SUBMITTAL TRANSMITTAL

Submittal No: 05500-009.A

PROJECT: **Harold Thompson Regional WRF**
Birdsall Rd.
Fountain, CO 80817
Job No. 2908

SUBJECT: Re-submittal for the Aeration Basin/Digester Stairs

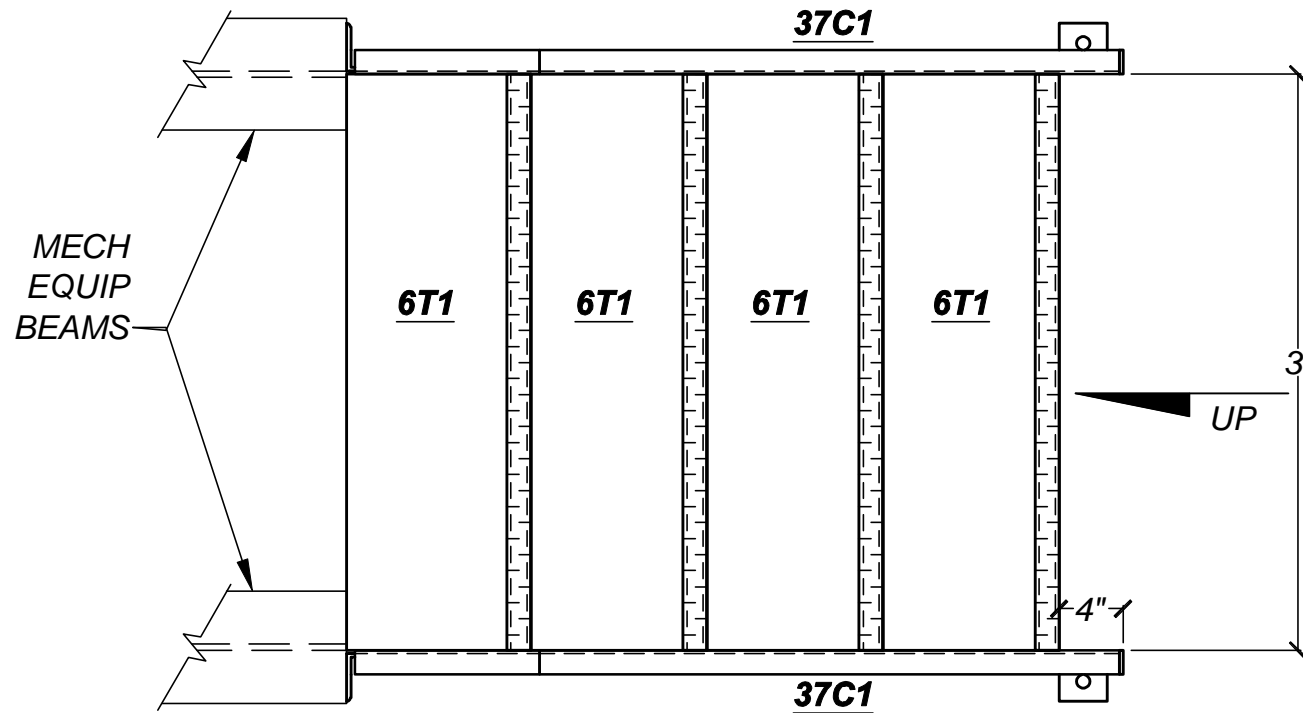
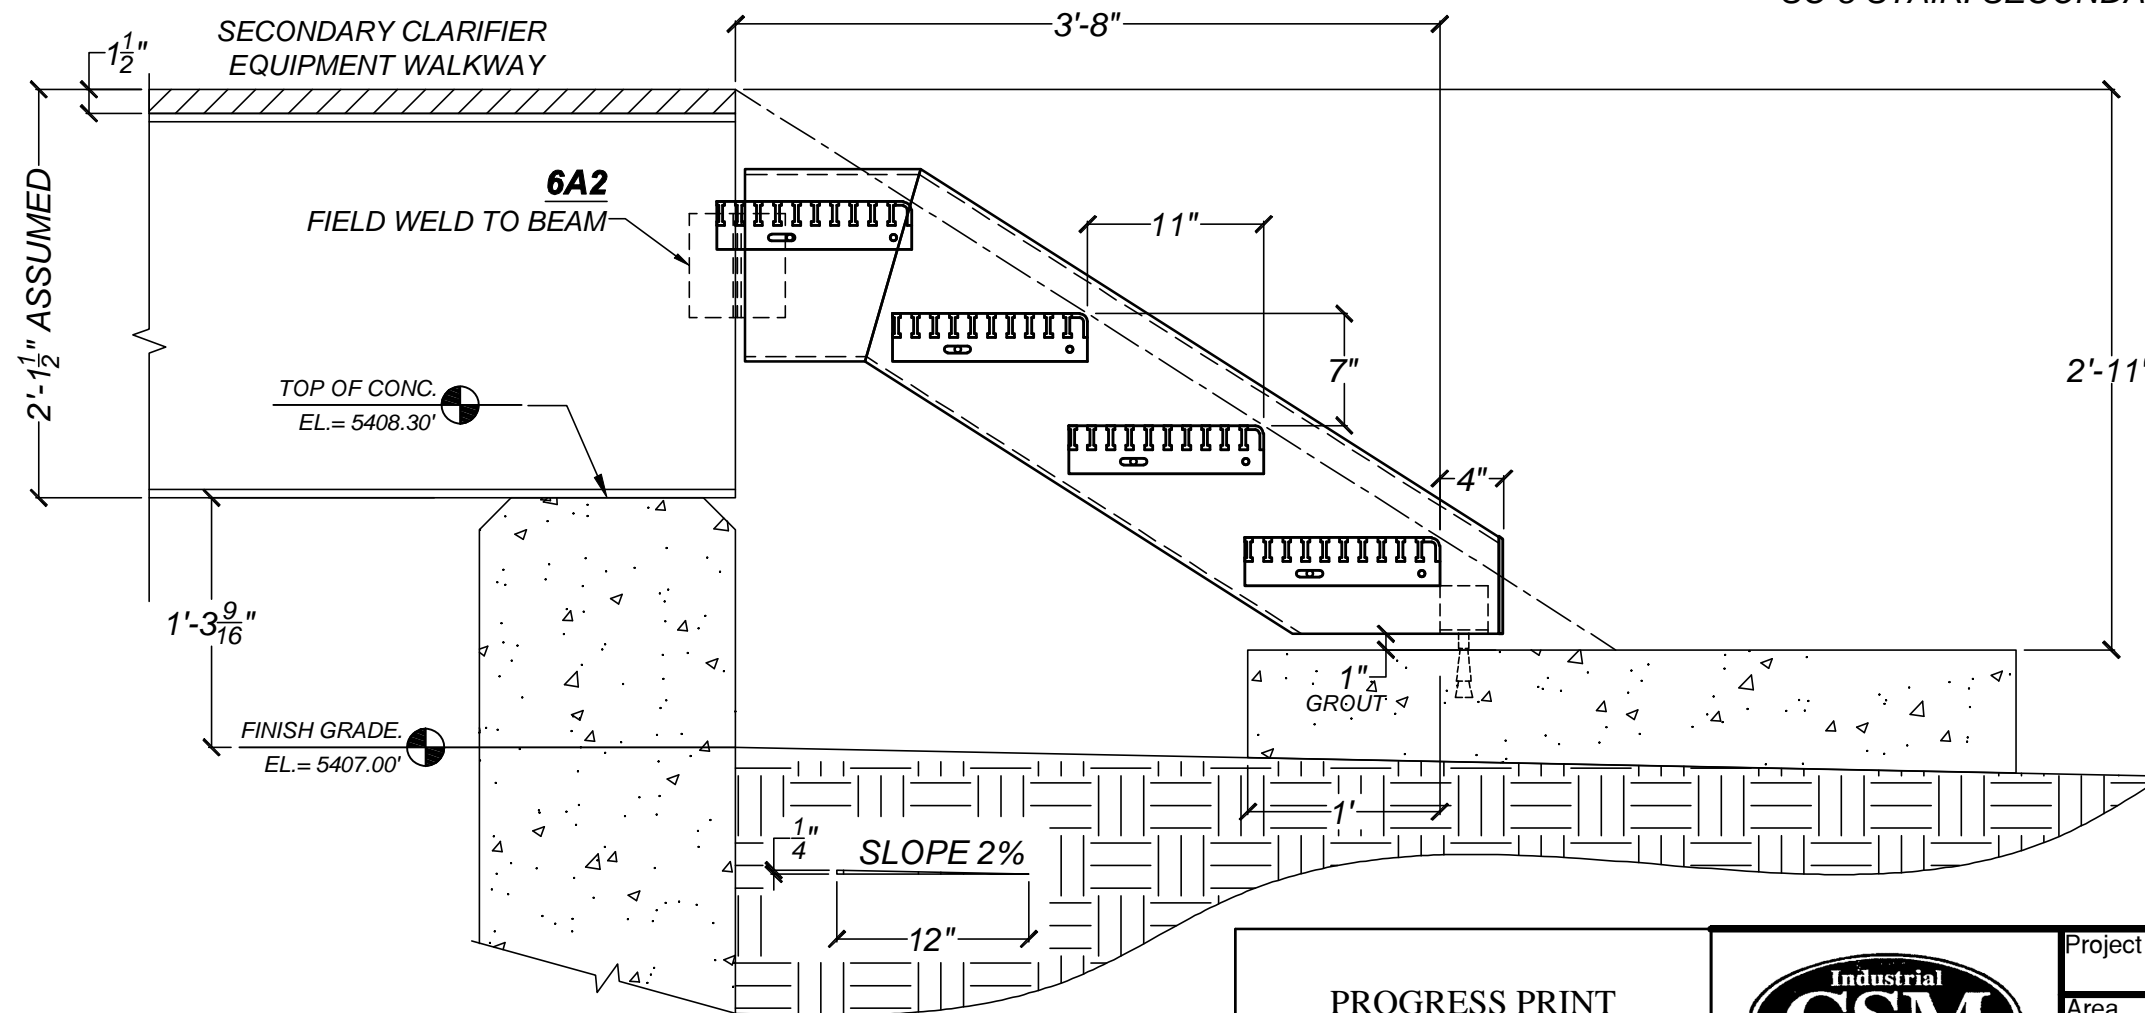
- a. A note on the drawing requests the Engineer provide the stair elevation, design, etc. We recommend the fabricator contact the Contractor who is purchasing the equipment and request the Contractor provide the as-constructed conditions of the secondary clarifier walkway and concrete slab at the base.

SHOP & FIELD NOTE:
 FIELD WILL NEED TO VERIFY ALL
 ELEVATIONS FOR CONCRETE. FIELD
 WILL ALSO NEED TO VERIFY THE STAIR
 CONNECTION INFORMATION SHOWN HERE
 TO CONNECT THE STAIR AT THE
 SECONDARY CLARIFIERS, PRIOR TO FAB.
